**PLANNING COMMISSION
SITE PLAN COMPATIBILITY WAIVER REQUEST REVIEW SHEET**

CASE: SP-2017-0081C

PROJECT NAME: South 5th Street Apartments

ADDRESS OF SITE: 2421 S 5th St

SP01

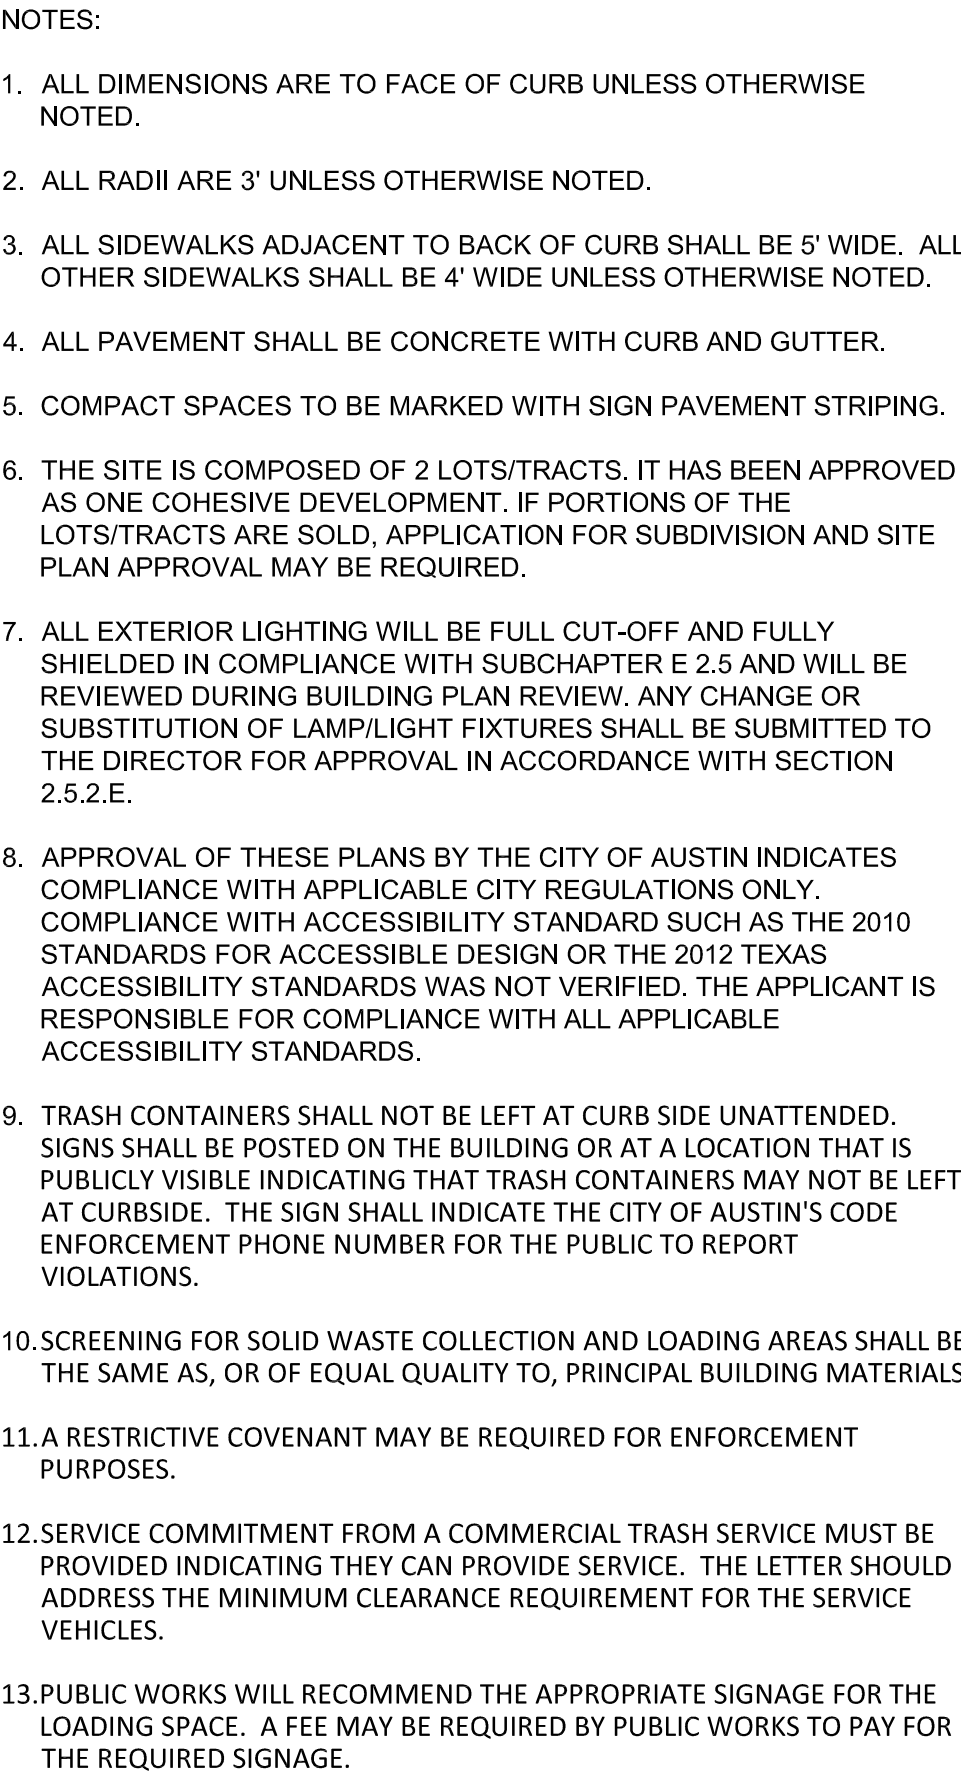
The applicant requests a waiver from a 25-foot to an approximately 5-foot compatibility setback for a sidewalk. The site is adjacent to live/work and multifamily to the north, single-family to the south, duplexes to the west, and a church to the east. The sidewalk will be adjacent to open space on the site on the south property line. All other compatibility setbacks are met.

Staff recommends approval of the waiver from LDC Section 25-2-1063 to reduce the Compatibility driveway setback requirement from 25 feet to approximately five feet from adjacent SF-3- zoned property used as single family.

Land Use: The applicant is requesting a waiver from Compatibility standards to reduce the setback for the sidewalk adjacent to the open space from 25 feet to approximately five feet in order to construct seven apartments in one building. The proposed building will be similar in scale and use to adjacent single-family residences, and will be screened with fencing and landscape. The site plan will comply with all applicable regulations upon site plan approval.
